Access Compliance Report

Public Rights-of-Way

Intersection ID: 14093	Main Street: E_4TH_ST	Cross Street: HAWTHORNE_LN	Location: N
ADA ID: 559EA2650736	Ramp Type: PerpDiag	Initial Pass/Fail: Fail	Overall Compliance: No
			Severity Score: 33.75

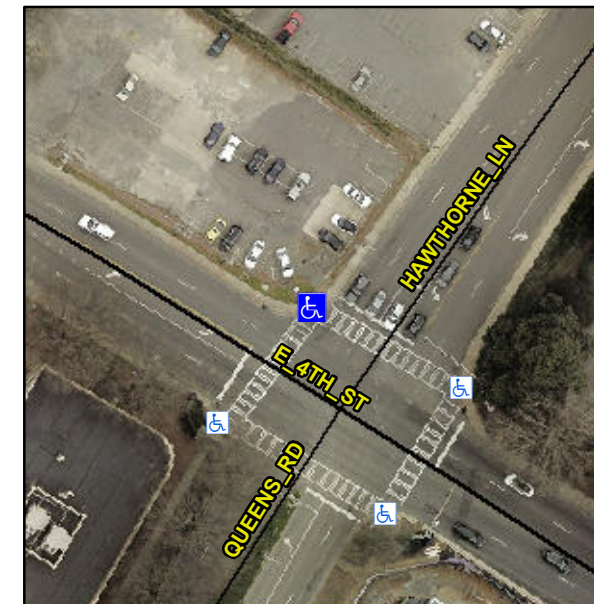
R304.5.1, R304.2.2, R304.5.3

Compliance	Description	Data	Compliance	Description	Data
N/A	Ramp Length (in)	54.0	No	Ramp Slope (%)	10.3
No	Ramp Width (in)	44.5	No	Ramp XSlope (%)	6.0
N/A	Flare Type LT	N/A	N/A	Flare Type RT	N/A
N/A	Flare Slope LT (%)	N/A	N/A	Flare Slope RT (%)	N/A
N/A	Flare Traversable LT?	N/A	N/A	Flare Traversable RT?	N/A
N/A	Landing Length (in)	N/A	N/A	DWS Provided?	N/A
N/A	Landing Width (in)	N/A	N/A	DWS Contrast?	N/A
N/A	Landing Slope (%)	N/A	N/A	DWS Length (in)	N/A
N/A	Landing X Slope (%)	N/A	N/A	DWS Full Width?	N/A
N/A	Landing Curb? (Y/N)	N/A	N/A	DWS Offset (in)	N/A
N/A	Shared Landing?	N/A			
N/A	Gutter Ponding?	N/A	N/A	Gutter Slope (%)	N/A
N/A	Gutter Lip Ht (in)	N/A	N/A	Gutter X Slope (%)	N/A
N/A	Painted X Walk1?	Yes	N/A	Painted X Walk2?	Yes
	X Walk 1 Direction	To SW		X Walk 2 Direction	To SE
N/A	X Walk 1 Width (in)	112.0	N/A	X Walk 2 Width (in)	114.0
	X Walk 1 Slope (%)	4.2		X Walk 2 Slope (%)	0.4
	X Walk 1 X Slope (%)	1.4		X Walk 2 X Slope (%)	3.9

Remove & Replace Curb Ramp With Two New Directional Ramps or Equivalent.
